VIRGINIA ELECTRIC AND POWER COMPANY
RICHMOND, VIRGINIA 23261

VIRGINIA ELECTRIC AND POWER COMPANY
NORTH ANNA POWER STATION UNITS 1 AND 2
INSERVICE TESTING PROGRAM FOR PUMP AND VALVES
THIRD TEN YEAR INTERVAL UPDATE
REQUEST FOR ADDITIONAL INFORMATION

**North Anna Unit 1
Inservice Testing Program
Revised Relief Requests**

**North Anna Unit 2
Inservice Testing Program
Revised Relief Requests**

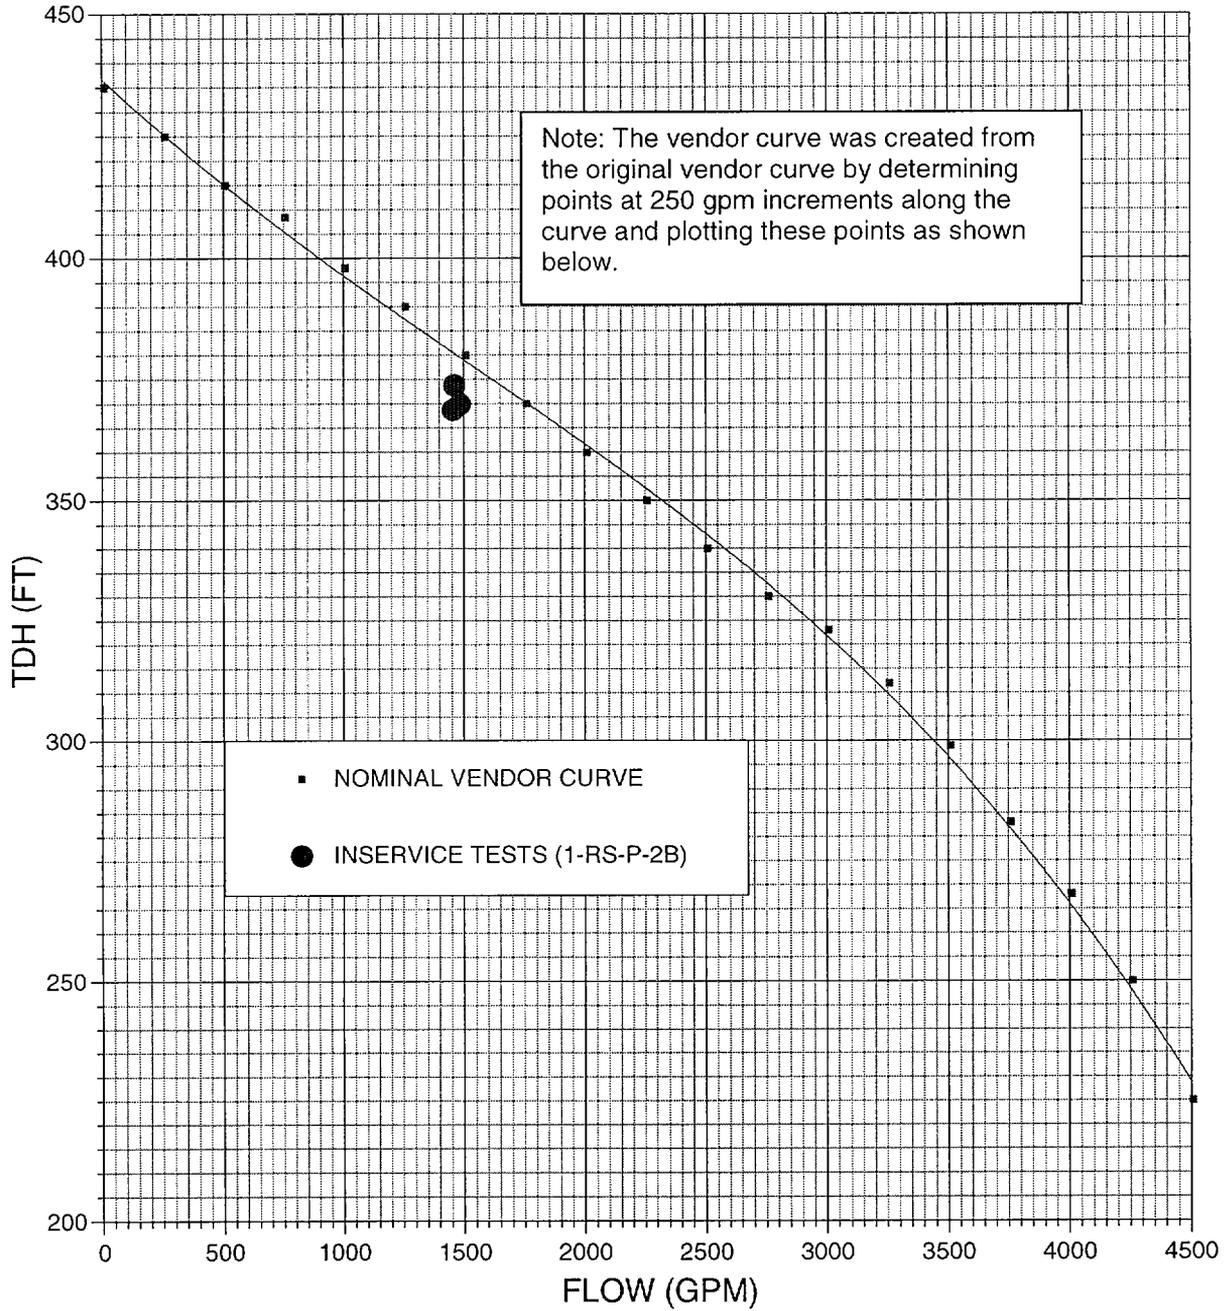
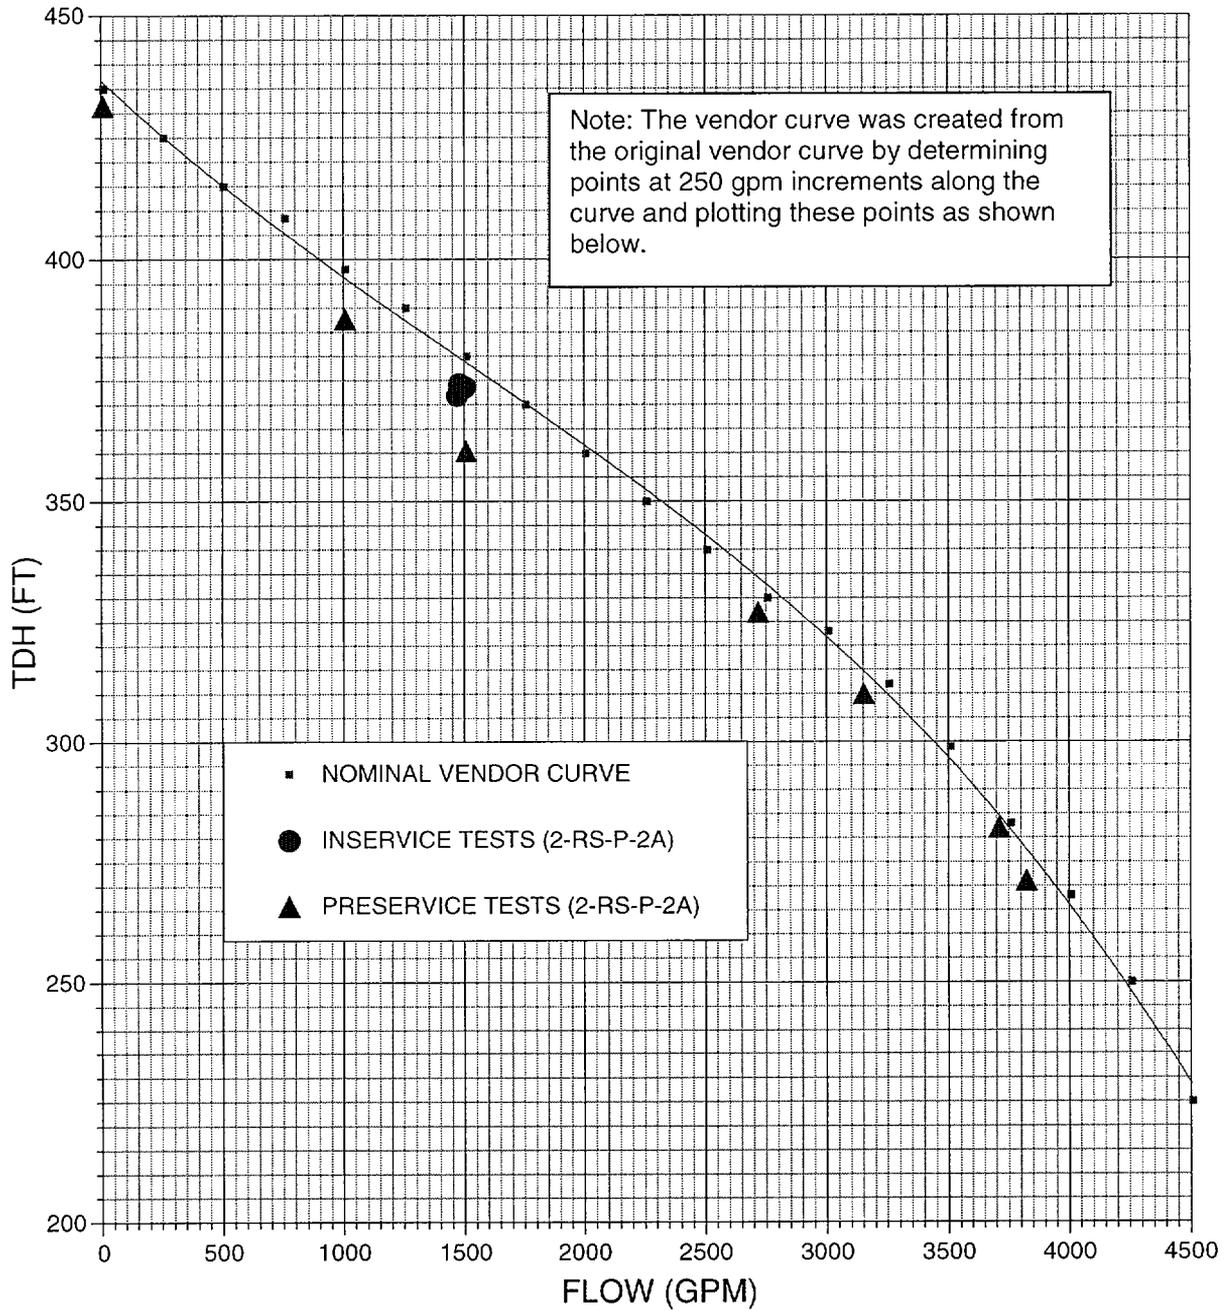
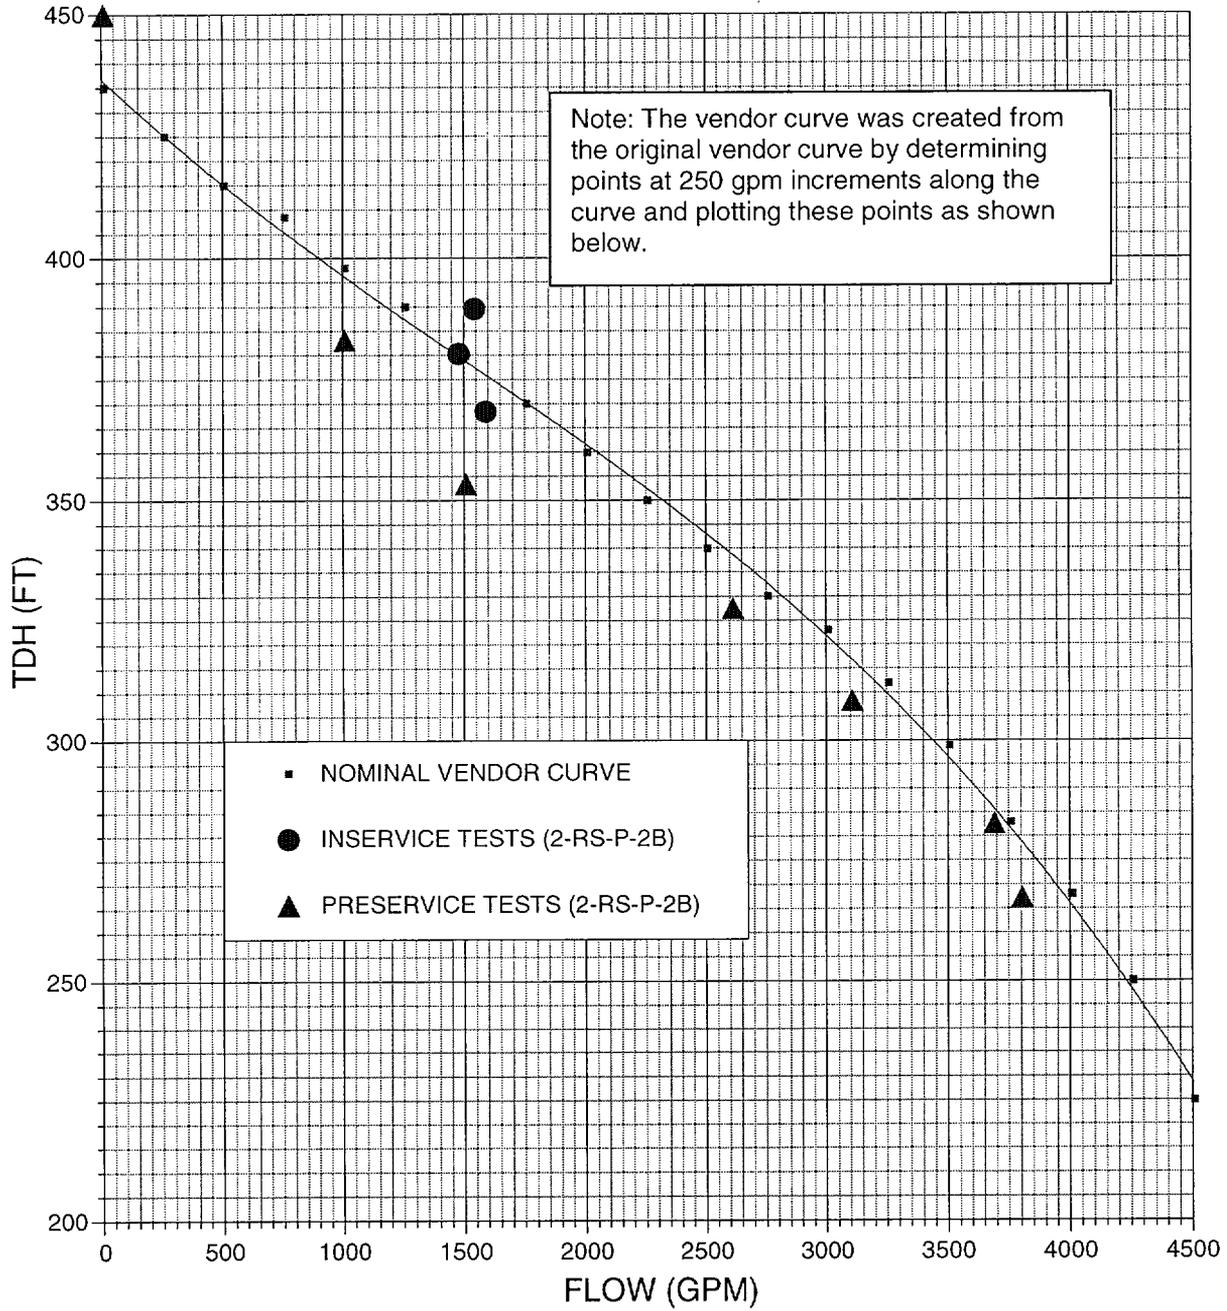
RELIEF REQUEST NO.	DESCRIPTION OF CHANGE
	The four figures following the document are provided to aid the NRC in evaluating the bases in P-6. These figures show the nominal vendor pump curve and IST data points for pumps 1-RS-P-2A and B, and 2-RS-P-2A and B. In addition, preservice data points are given for the Unit 2 pumps. There were no preservice tests performed for the Unit 1 pumps.
P-7	For auxiliary service water pump 1-SW-P-4, the need for and consequently the request for relief from the discharge pressure instrument accuracy requirement was eliminated. Based on guidance from ASME OM Interpretation 95-6, certain terms in the instrument loop accuracy calculation can be excluded, resulting in a calculated value for loop accuracy that is within $\pm 2\%$. In the alternate testing section, 10 CFR 50.55a(a)(3)(i) was added as a reference.

FIGURE P-6.1

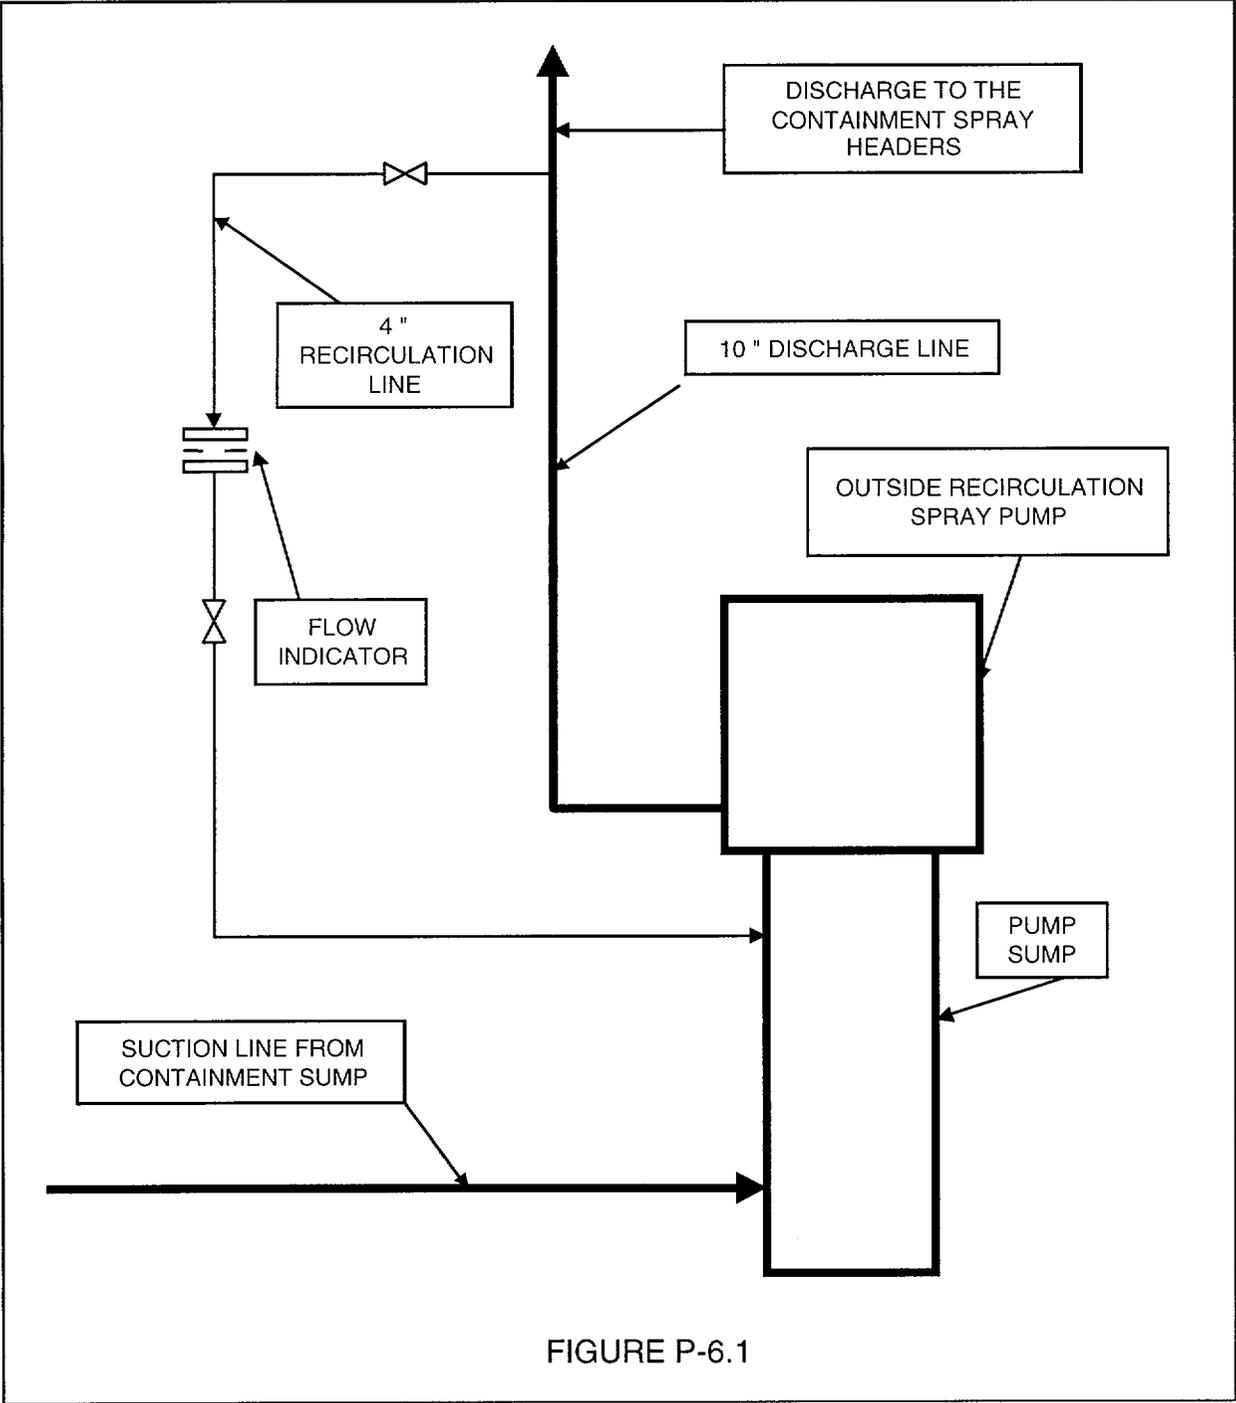
The test loop for the outside recirculation pumps consists of a 10" pump discharge line feeding into a 4" recirculation line which feeds back to the pump sump. Refer to Figure P-6.1. With this test loop, pump design flow cannot be established. Also, the discharge piping was not designed to be temporarily reconfigured so that pump design flow could be achieved.

As an alternative to flow testing at the design flow rate, the test loop shown in Figure P-6.1 will be used. Reference flows are typically established with this test loop in the range of 1450 to 1500 gpm, whereas the pump design flow is 3640 gpm. The low reference flows result from restrictions due to the small 4" recirculation line and the limited volume of water in the test loop. The limited water volume results in a rapid temperature rise in the test loop due to heat loads added by the running pump. This temperature rise affects repeatability of the measured hydraulic parameters. Therefore, care must be taken to ensure that the pump run time is limited and that the flow rate is maintained within an optimal range.

FIGURE P-6.2

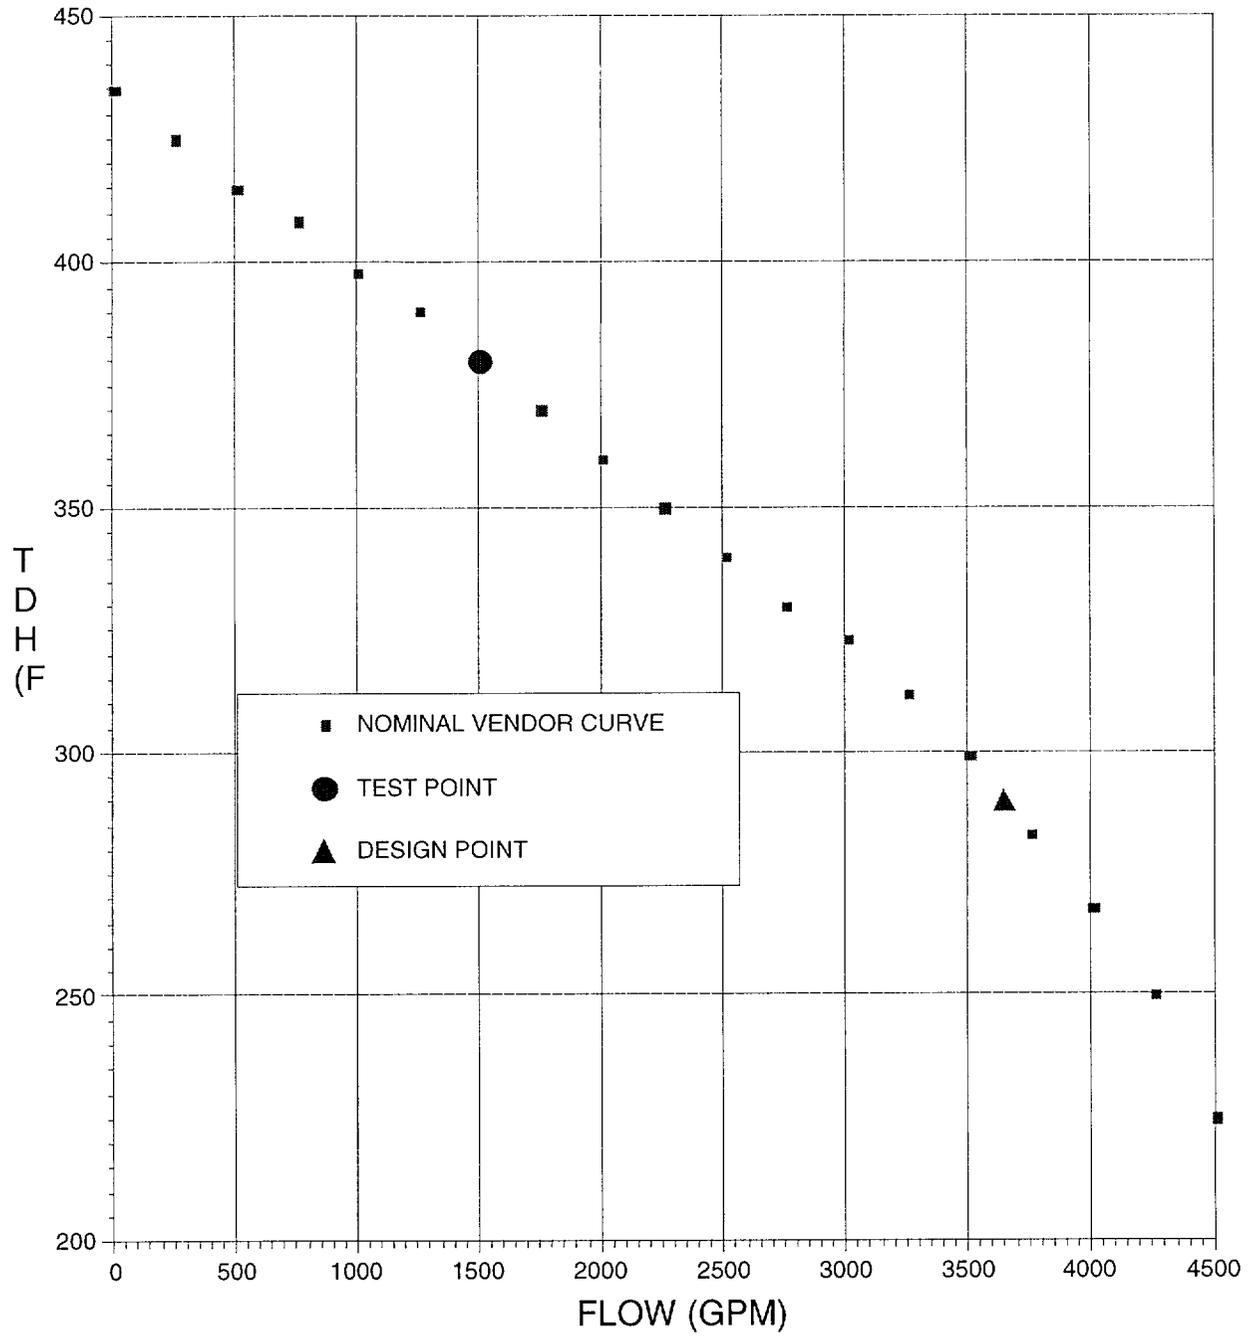
In the 1450 to 1500 gpm range of the head curve for these pumps, the head curve is not flat, but well sloped. Refer to Figure P-6.2. Therefore, as performance degrades due to internal recirculation caused by increasing internal pump clearances, the differential pressure will measurably decrease for a given reference flow rate. As discussed above, testing the outside recirculation spray pumps over the full range of the pump curve and measuring at least five points along the curve is impractical.

As an alternative to testing within 20% of the design flow, the reference values will be established at approximately 40% of the design flow. It is our understanding that testing at design flow is important for pumps with characteristic head-flow curves that are flat or gently sloping in the low flow region (little change in developed head with increasing flow). In the low flow region, increasing internal flows, usually due to wear, are difficult if not impossible to detect. Pumps with the "flat" curves at low flows should be tested at near design conditions to determine if increasing internal recirculation flows have degraded pump performance to the point where design requirements cannot be met. This situation does not apply to the outside recirculation pumps if they are tested at 40% of design flow. Testing at the reference flows will detect pump degradation because the pump curve is well sloped at the point of testing. Refer to Figure P-6.2.
